Greensmaster® 3250-D

Subject: Breather Tube Replacement Prevents Engine Damage

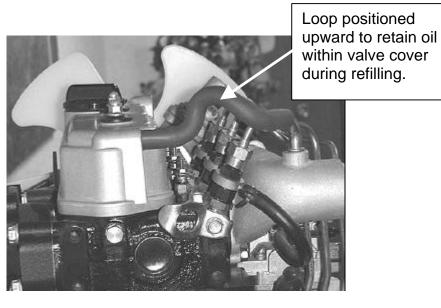
When refilling or "toping up" engine oil, if the oil is added too rapidly, the oil level in the valve cover chamber may rise above the breather tube outlet. If this condition occurs, clean oil may be ingested into the cylinders, via the intake manifold, which may result in hydraulic lock and can cause serious engine damage.

To prevent this from occurring, install a new Breather Tube (104-7743) on all products listed above. This tube has a molded loop that is positioned upward to prevent oil from flowing into the air intake manifold.

- 1. Remove the old breather tube connecting the intake manifold to the outlet on the valve cover.
- 2. Install new Breather Tube with loop oriented upward as shown below.
